**Re: Magpie Diversion**

## MAGPIE DIVERSION

Picture 2. Damaged outlet of 8.8 ft. culvert.

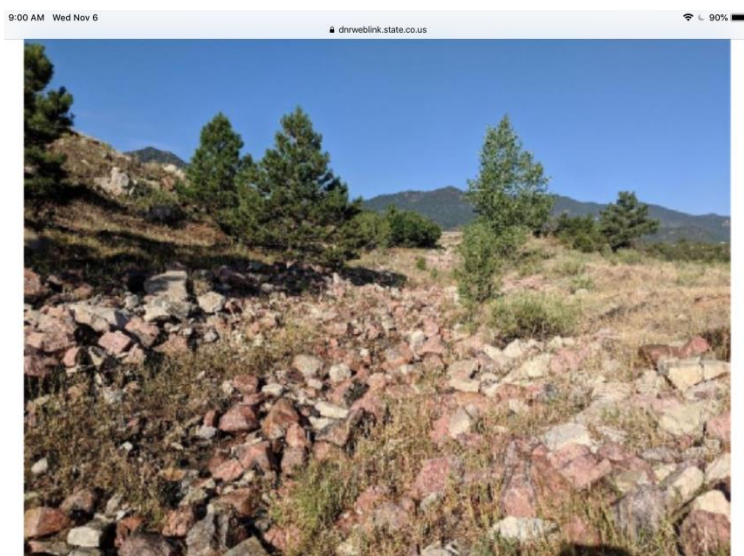
The cross-sectional area of the inlet is reduced 16%.<sup>8</sup> The culvert outlet is also bent reducing the flow capacity.

The center portion of the culvert directly underneath the haul road has been compressed so that the cross-sectional area is reduced. How much reduction in flow caused by these problems is unknown because Federal Culvert Charts do not have information covering this type of culvert inlet, outlet, and compression damage.
